Staff Report

Meeting Date: August 19, 2024

Project Name: Pho Real Rear, Enclosed Patio Addition

Case Number: COA24-0002

Figure 5: Proposed north elevation, 2399 W. Main St.

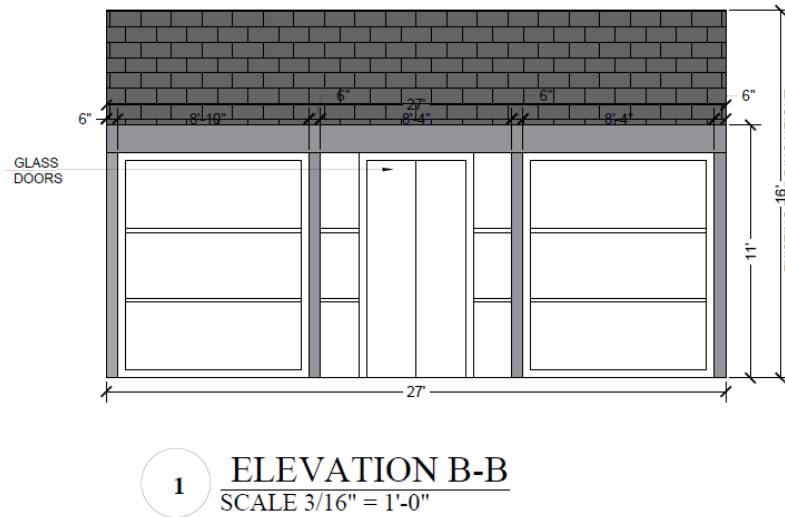
~~A 1ft overhang is proposed on all three elevations and sits at about 8ft above ground level.~~ *The applicant removed the 1 ft overhang on the east and west elevations, per recommendations from staff and the HPC, and kept the overhang on the north elevation.*

The elevations are not consistently divided vertically and instead are dependent on the width of the wall and inclusion of glass doors. ~~The north elevation features six vertical sections of glass with a 5ft wide double, glass door located on the center of the elevation. The vertical sections are 4ft 5 in wide, with the two sections closest to the doors being 1ft 8 in.~~ *The north elevation is divided into four vertical sections with a 5ft wide double, glass door located on the center of the elevation. This is a reduction from six vertical sections in the original submittal. The vertical sections are 8ft-4in wide, with the two sections closest to the doors being 1ft-8in wide. The measurements for this elevation are inconsistent between what is noted and the actual measurement based on the scale. The vertical section east of the door is noted as 8ft-10in wide, but when measured using the scale provided, the measurement is indicated as 8ft-4in wide. It appears the written measurement includes the 6in post when it should exclude it. Measurements in the final submitted plan set will need to be accurate and consistent, prior to final issuance of the COA, should the HPC approve the application.*

STAFF RECOMMENDATION: Staff is recommending that HPC Resolution 02-2024 *be conditionally approved, requiring that the applicant submit an updated final plan set which provides accurate and consistent measurements for the northern elevation.* ~~be continued to the August 19, 2024 meeting to allow sufficient time for the applicant to address inconsistencies in the application. Continuation will allow staff time to review any changes and present an item on which the Commission can act.~~

Figure 6: Proposed east elevation, 2399 W. Main St.

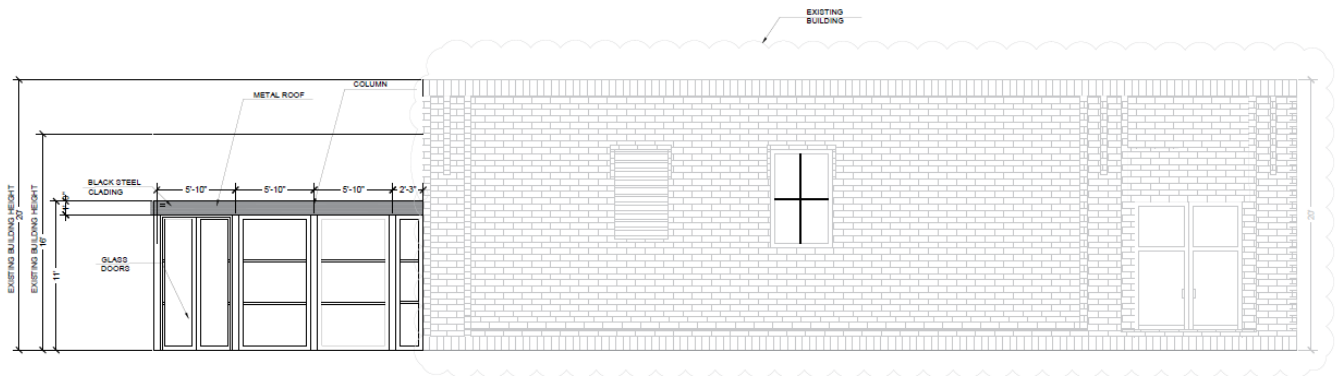
The east elevation is divided vertically into four sections, with three at 5ft-10in and the fourth, closest to the historic building, at 2ft-3in. The west elevation is divided into five vertical sections *with the northernmost section containing a double door that appears to be 5ft in width, as measured on the plans.* ~~with a 3ft 9 in, double glass door. The door is located on the north side of the elevation about 9.5 inches from the northeast corner of the addition.~~ The remaining vertical sections, ~~not adjacent to the doors,~~ are 5ft-10in, with a 2ft-3in section closest to the building.

The proposed addition does not destroy historic materials that characterize the property. The proposed work is differentiated from the existing building and compatible. ~~in all areas except architectural features. The proposed 1 ft overhang on the west and east sides of the addition is not a compatible architectural feature. The overhang extends beyond the historic building and is not referential of any architectural feature on the building. The criterion is **not** fully met.~~ *The applicant removed the previously included 1ft overhang. This standard appears to be met.*
